## Fwd: MOONRISE

From: **Max Winters** <max.w@spectra-eng.com>  
Date: Tue, Oct 21, 2025 at 2:50 PM  
Subject: RE: MOONRISE  
To: Murray Johnson <jmjcoinc@gmail.com>

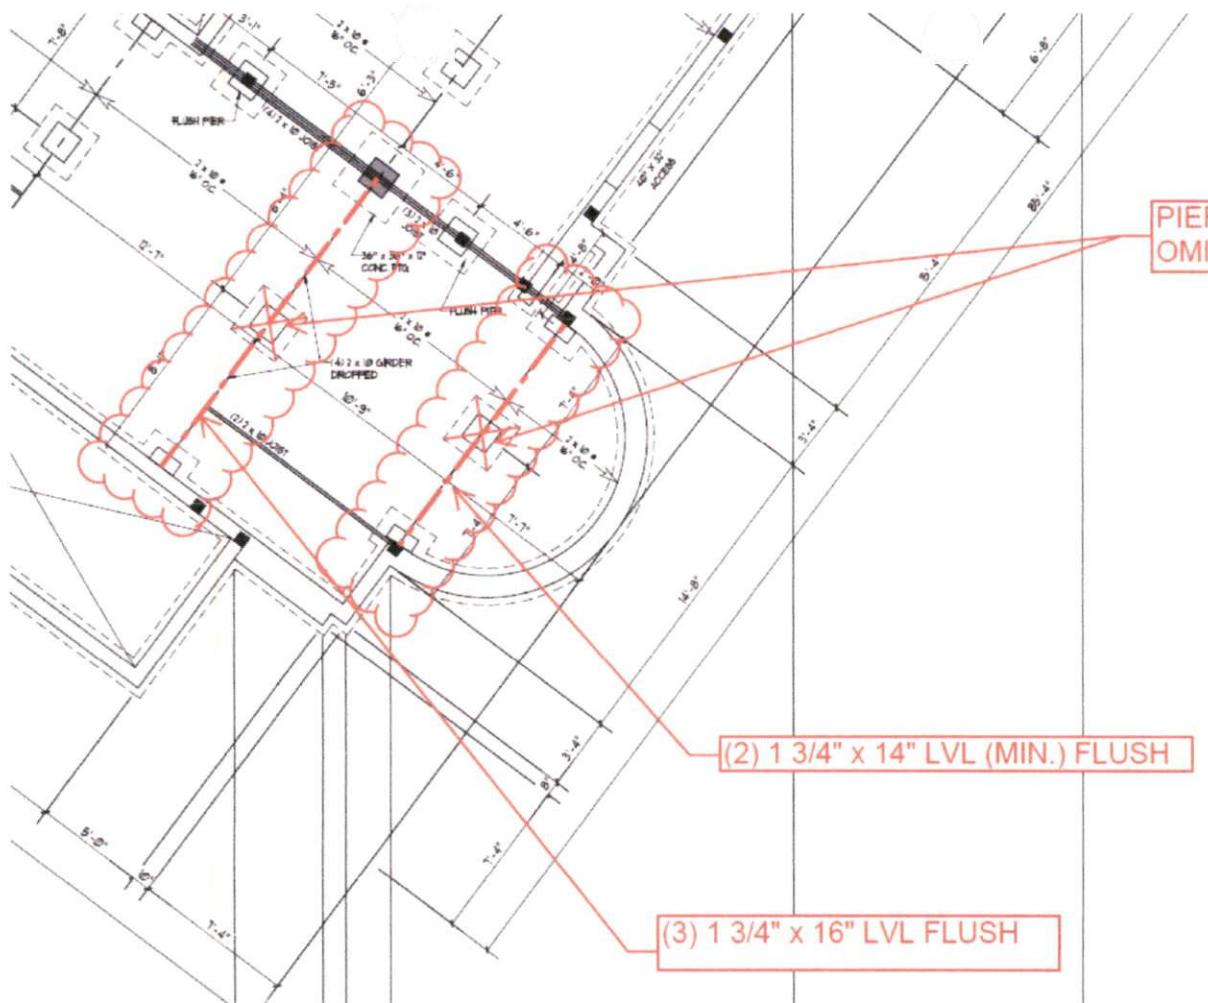
For the longer spanned girder near the middle of the master bedroom, let's go with a (3) 1 3/4" x 16" LVL with the top set flush with the top of the floor joists. You'll have to build up the treated sill plate (or part of the pier) by an inch or so at each end. For the shorter girder at the sitting area, I'd suggest going with a (2) 1 3/4" x 14" LVL (minimum) with the top set flush and the sill plates built up as described for the other girder. You could also technically go with a dropped (4) 1 3/4" x 9 1/4" LVL for the sitting area girder, but those plies will need to be secured together with structural screws – I would expect the 2-ply LVL option to be more economical (plus it provides a little extra headroom and will perform much better). Provide ~8" bearing for these girders at each end. The existing footings are fine with the added load.
